CAMELOT PARC TOWNHOMES JSP25-02

JSP25-02 CAMELOT PARC TOWNHOMES

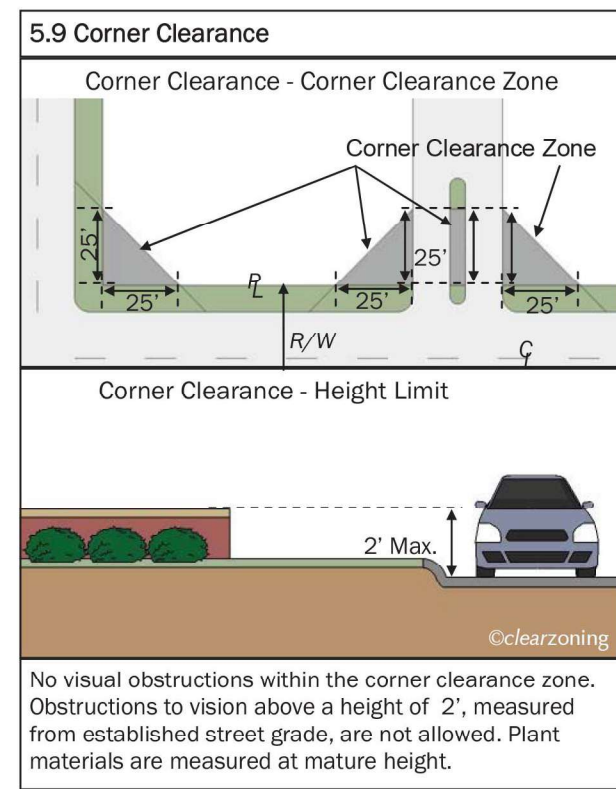
1. This table is a working summary chart and not intended to substitute for any Ordinance or City of Novi requirements or standards.
2. The section of the applicable ordinance or standard is indicated in parenthesis. For the landscape requirements, please see the Zoning Ordinance landscape section 5.5 and the Landscape Design Manual for the appropriate items under the applicable zoning classification.
3. Please include a written response to any points requiring clarification or for any corresponding site plan modifications to the City of Novi Planning Department with future submittals.
